## HISTORIC PRESERVATION BOARD

**PUBLIC HEARING  
95 INDIA STREET (REAR of 63 FEDERAL)**

**TO:** Chair Sheridan and Members of the Historic Preservation Board  
**FROM:** Deb Andrews, Historic Preservation Program Manager  
**DATE:** March 14, 2019  
**RE:** March 20, 2019 **PUBLIC HEARING**

**Application for:** Certificate of Appropriateness for Residential Building Addition

1 EAST ELEVATION  
SCALE: 1/4" = 1'-0"

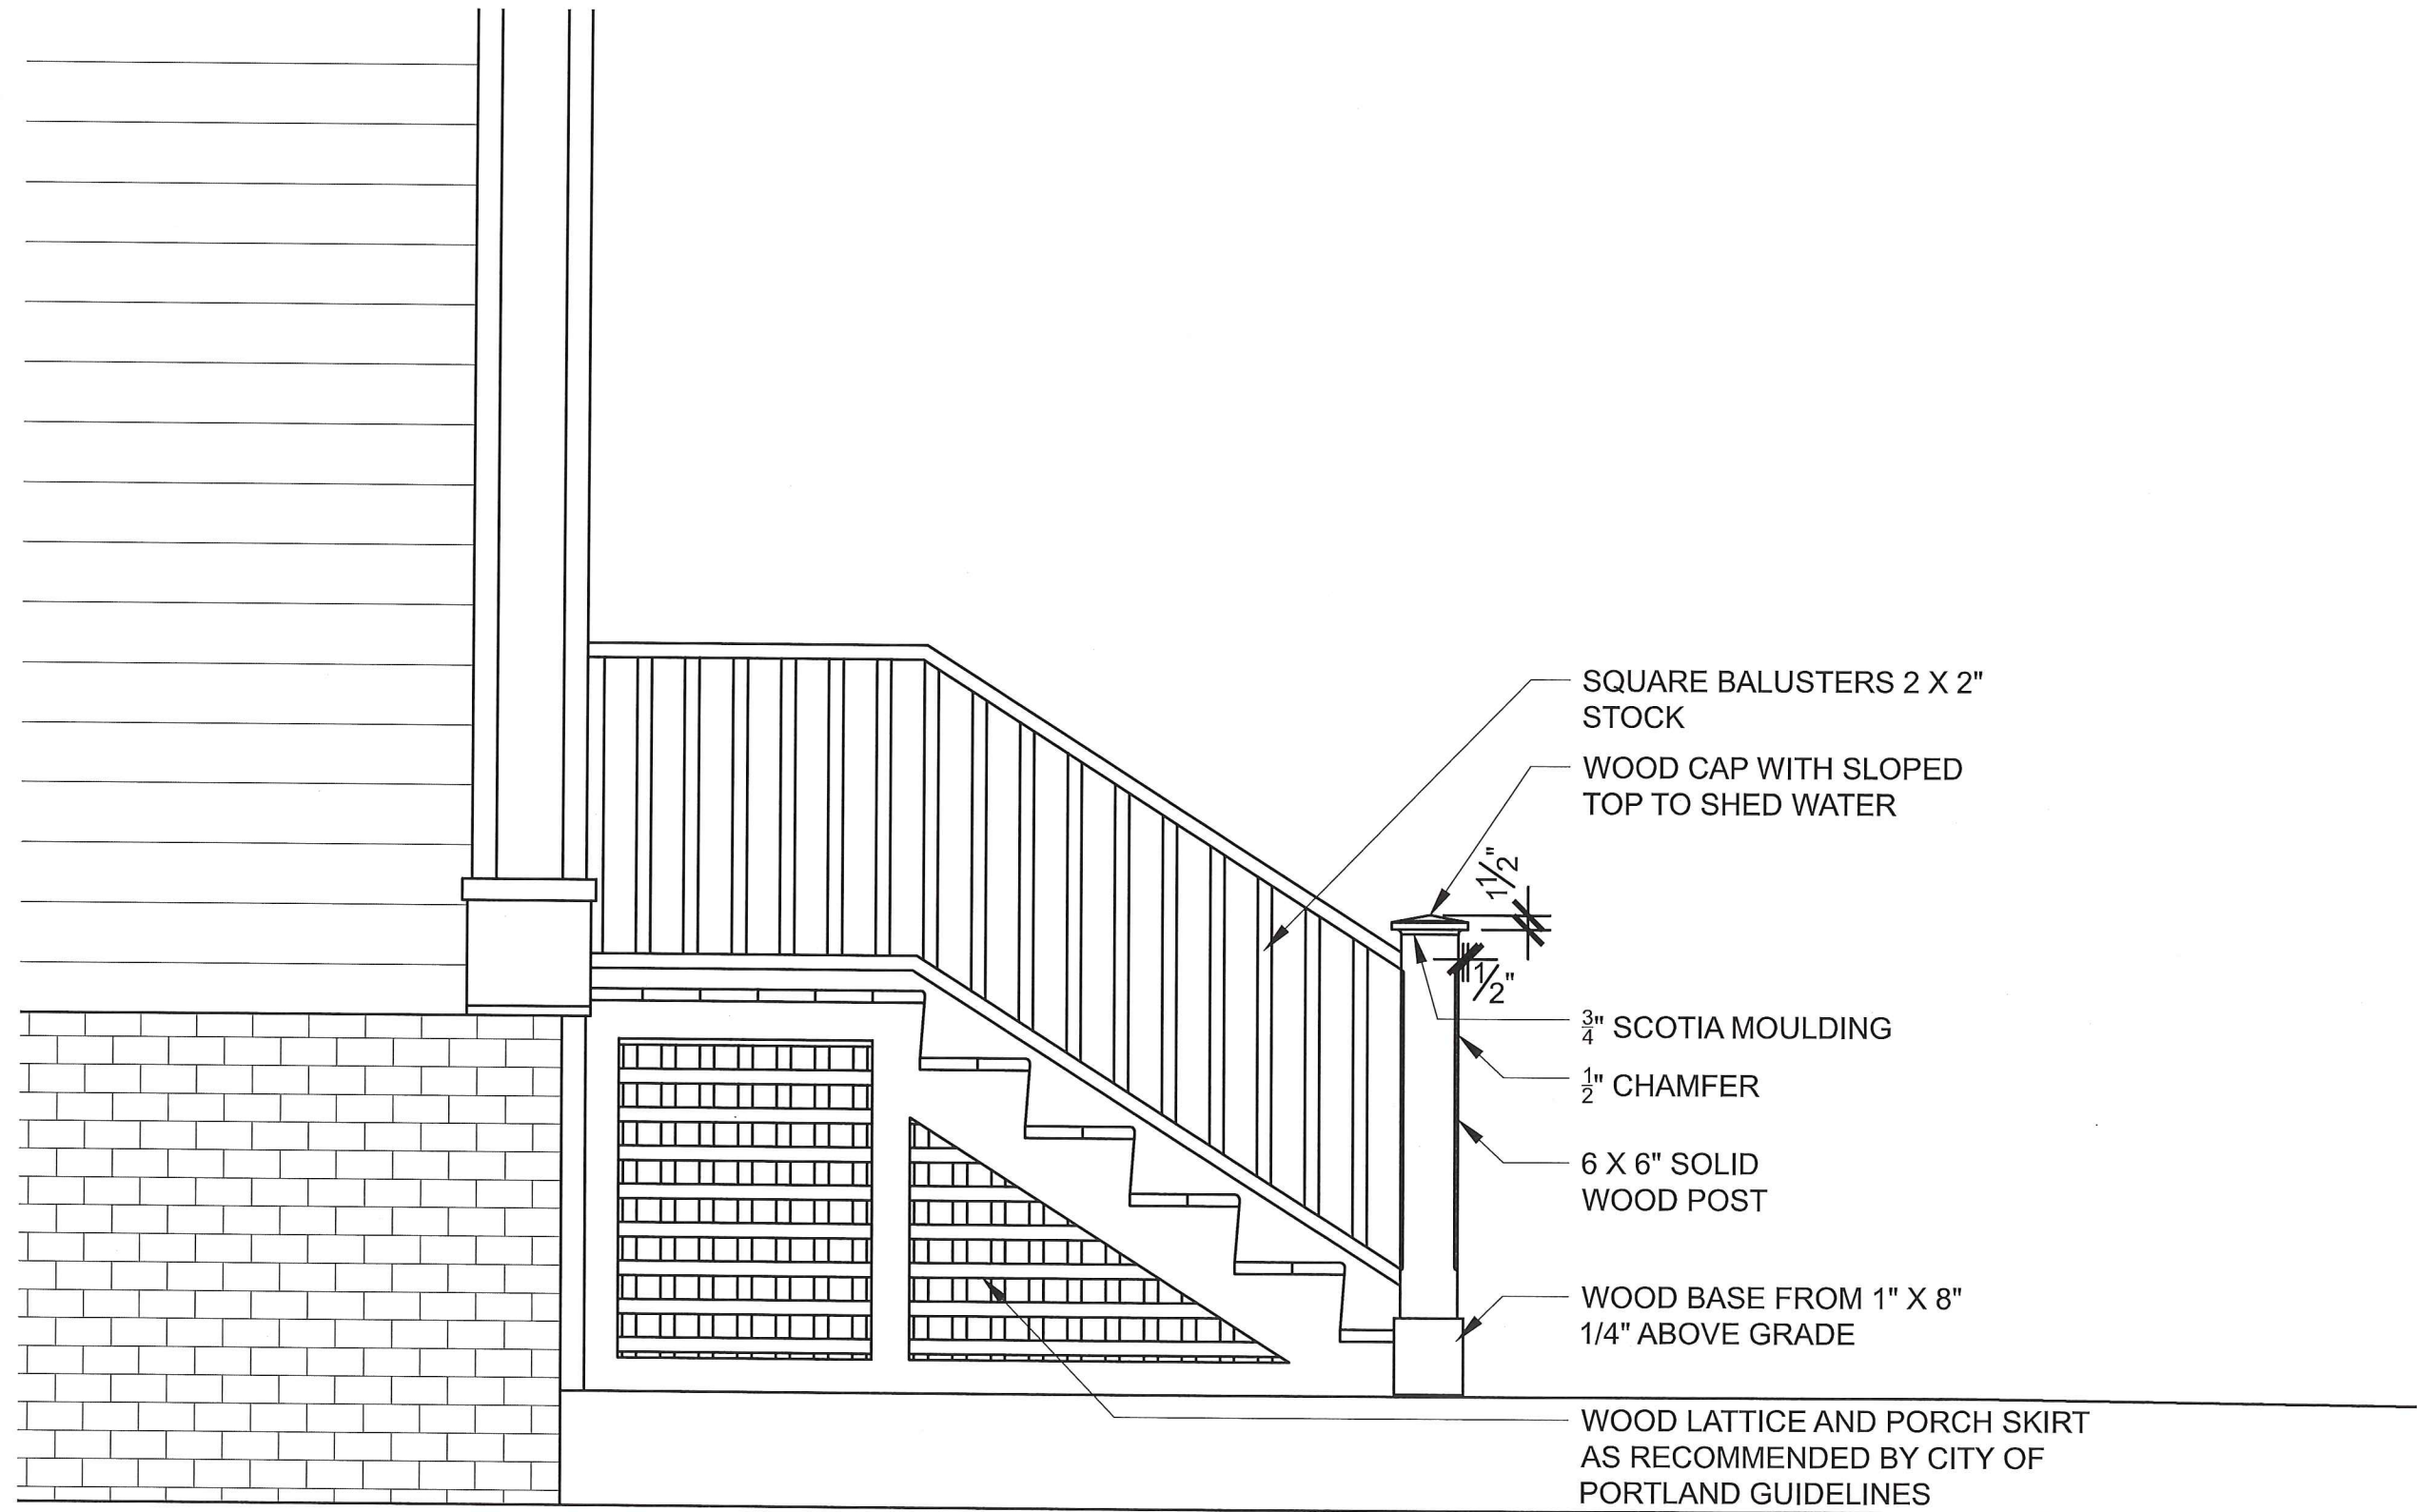
DORMER SLOPE EDITED FROM 3:12  
TO 4:12

1 SOUTH ELEVATION  
SCALE: 1/4" = 1'-0"

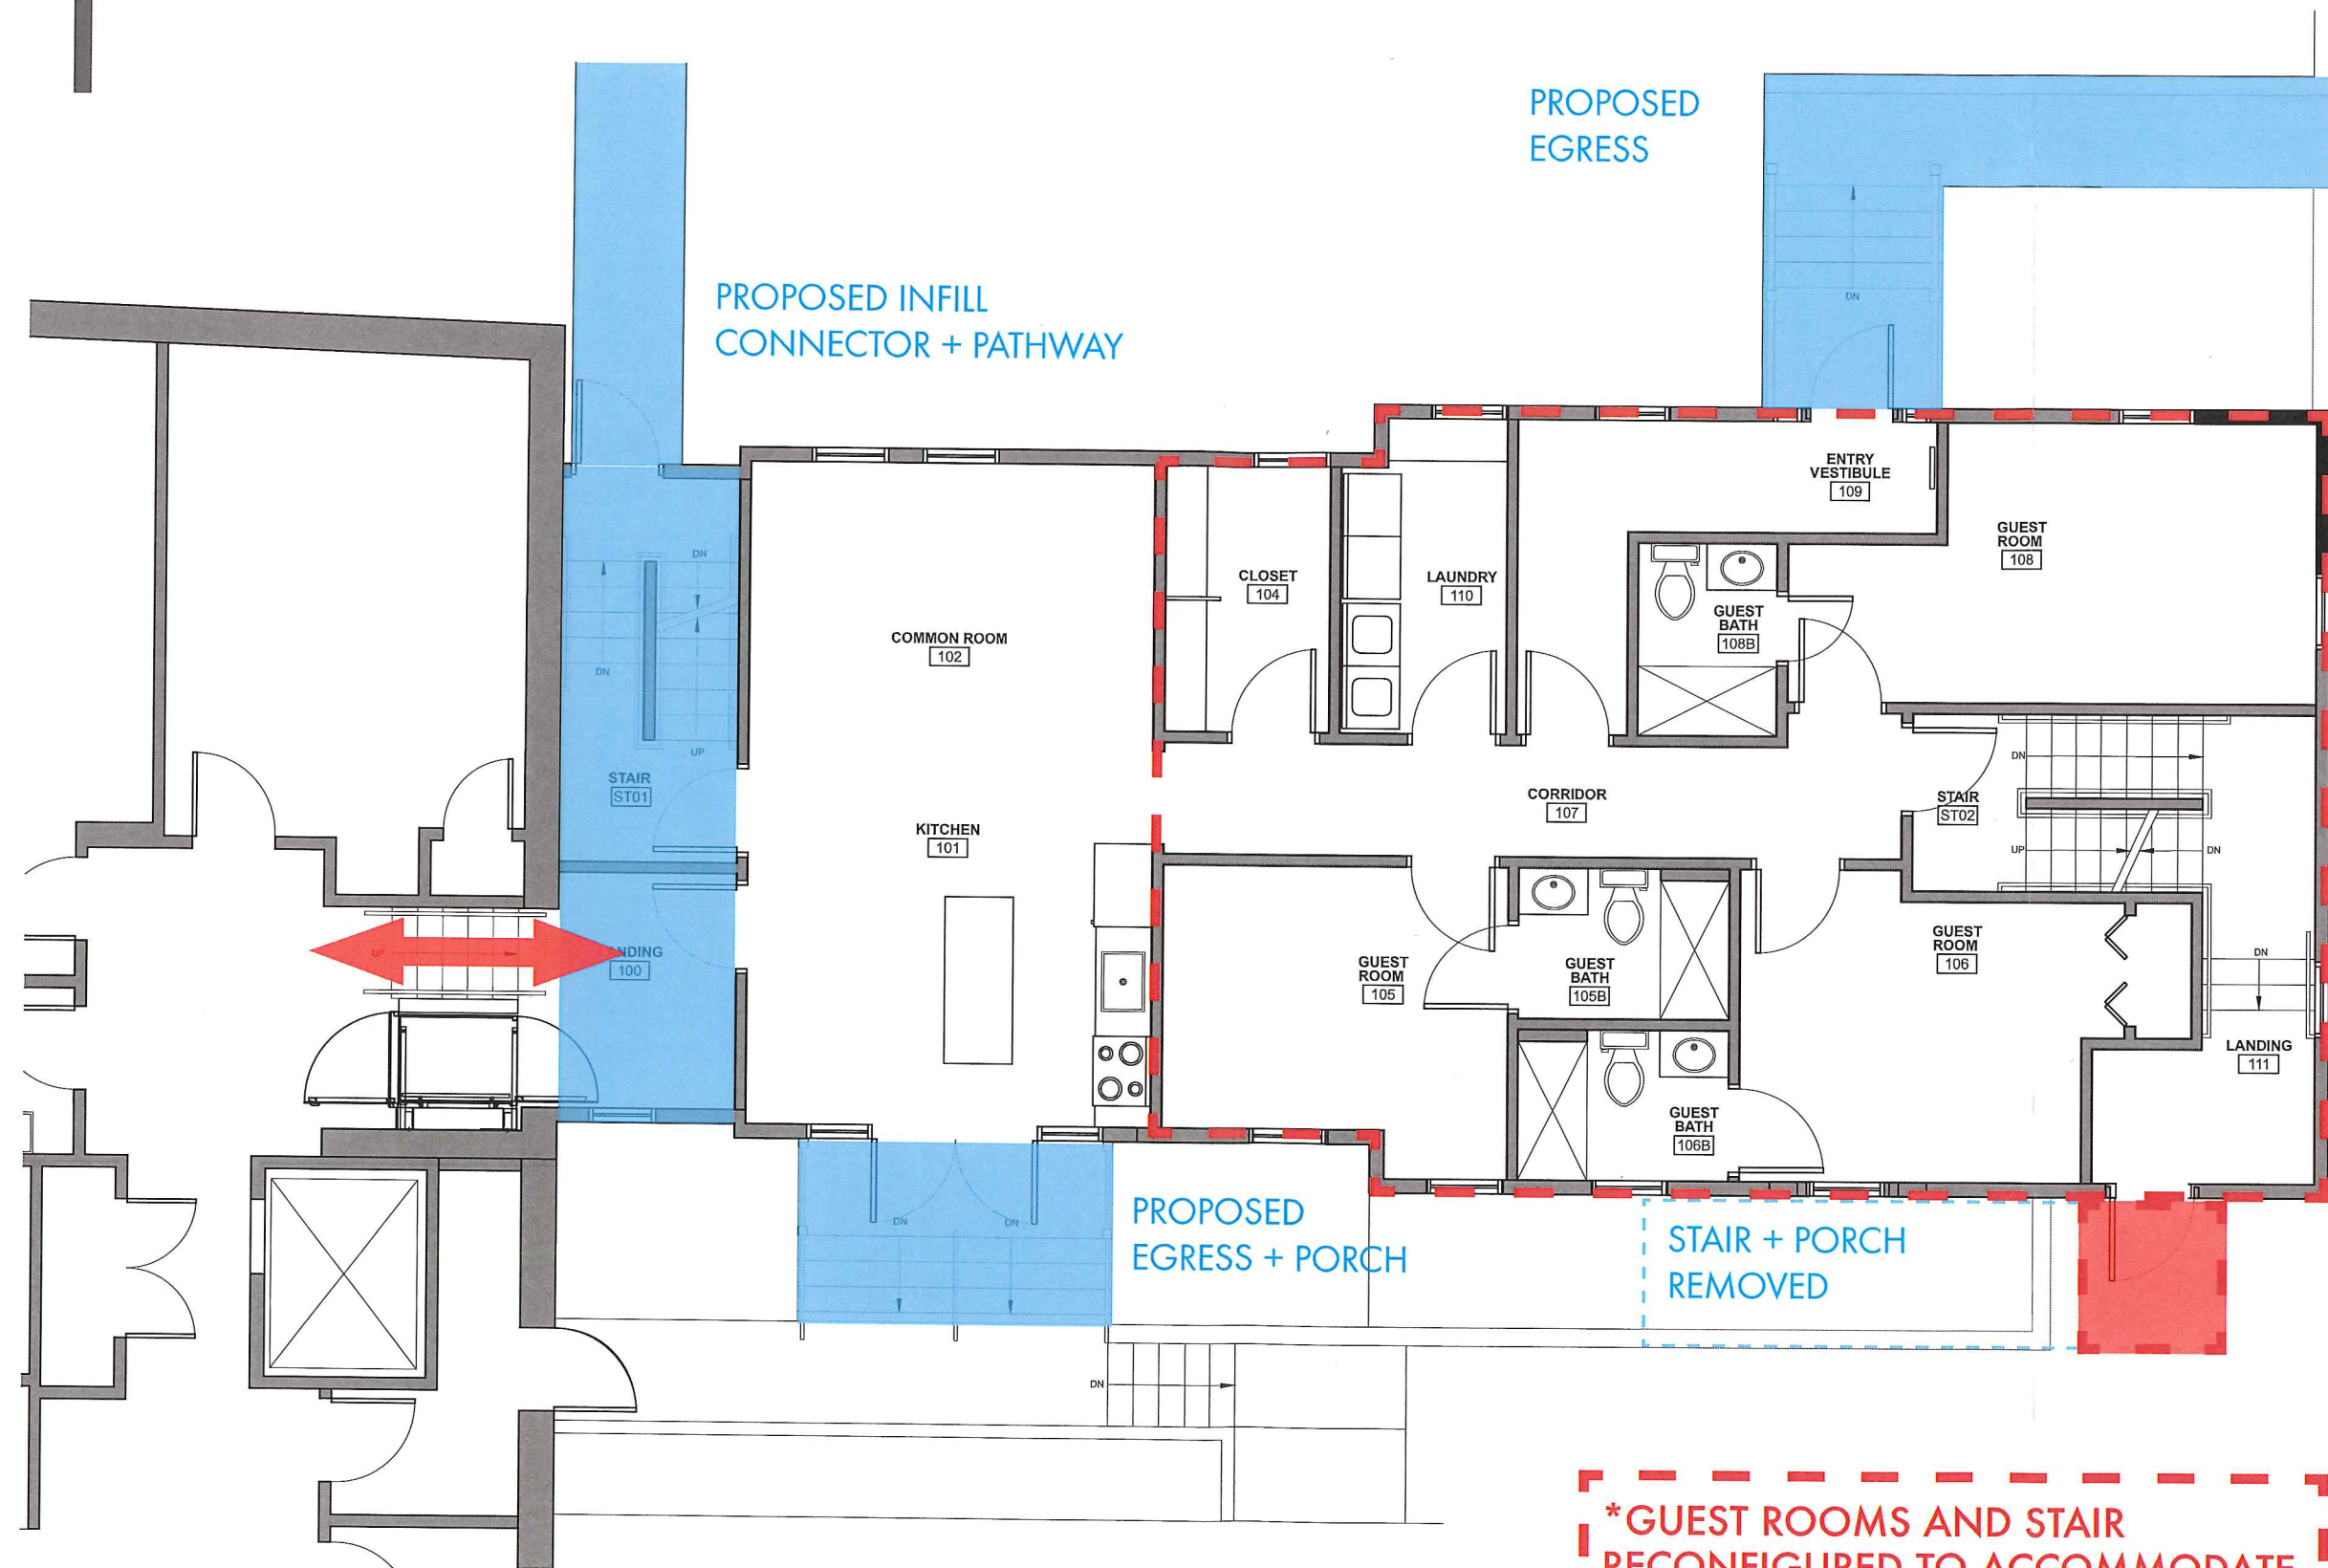
DORMER SLOPE EDITED FROM 3:12  
TO 4:12, NEW EGRESS DOOR  
LOCATION

1 | SITE PLAN  
1/8" = 1'-0"

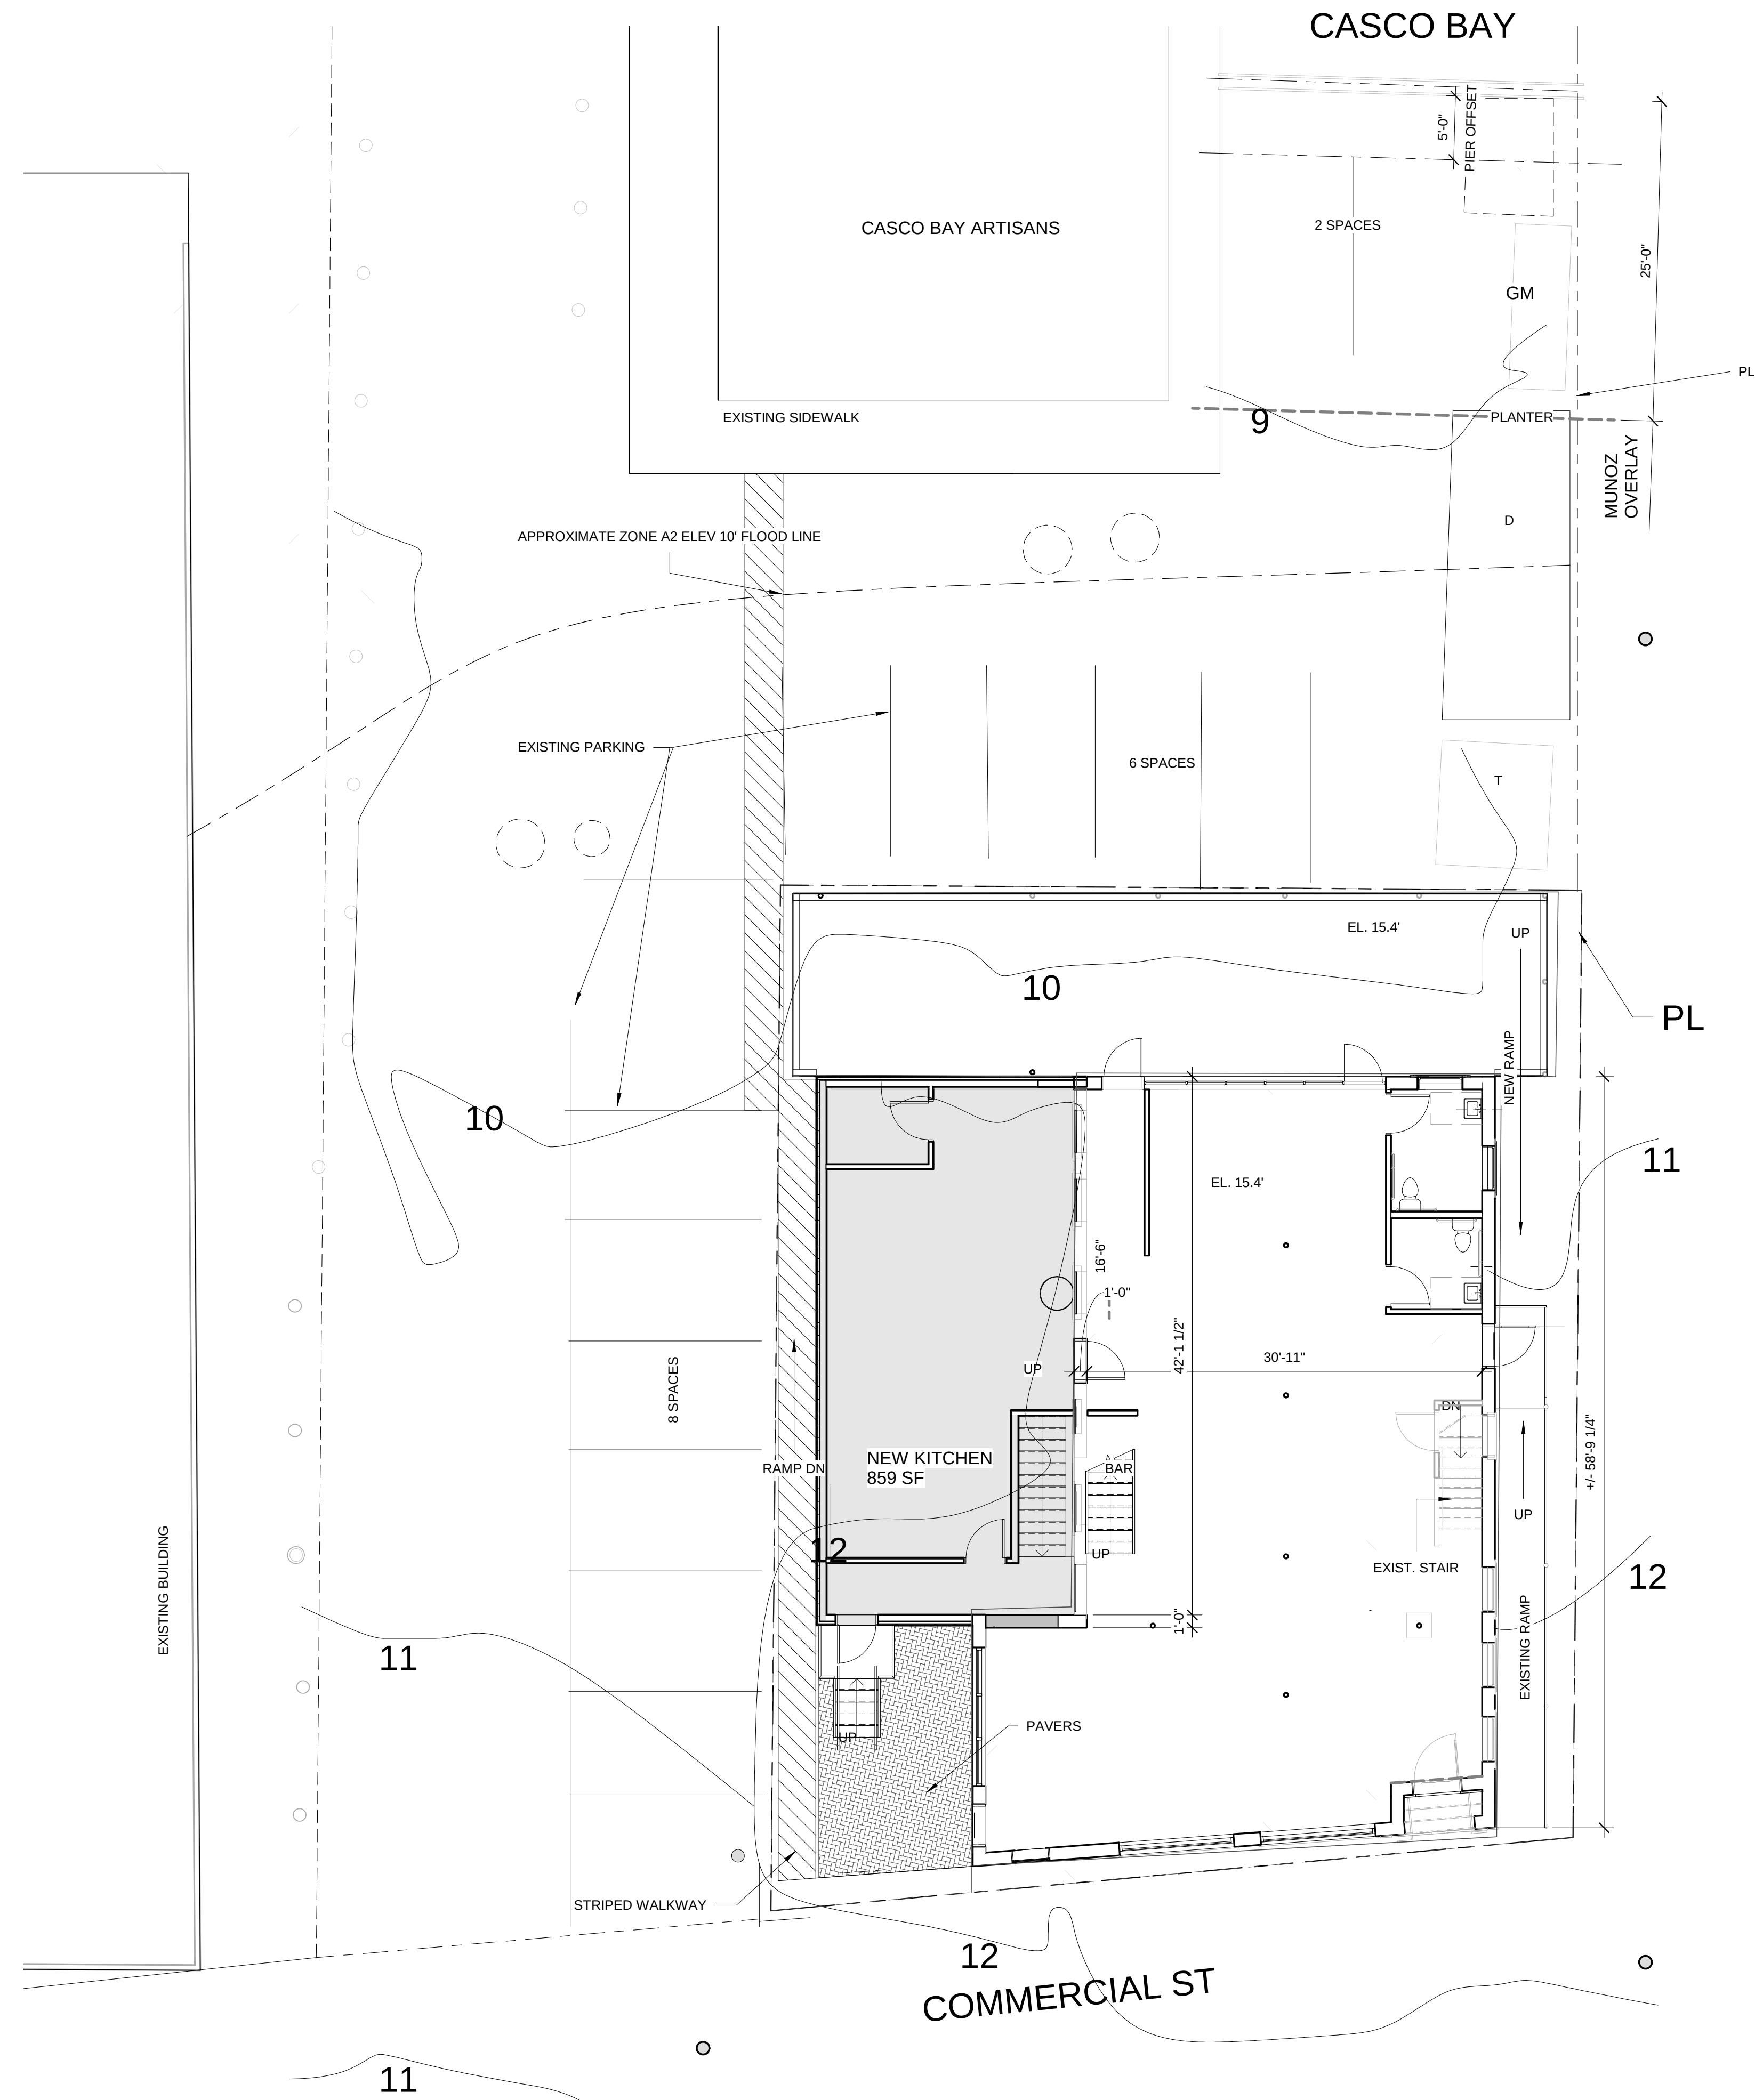
- The small plaza in front of the addition is shown with pavers that contrast with the public brick sidewalk (no specification or sample has been supplied.) Note that on the site plan (Sheet A1.00) the pavers are shown correctly, extending to the front corner of the building. In the renderings the pavers do not extend all the way to the front sidewalk; staff believes the site plan shows the design intent.
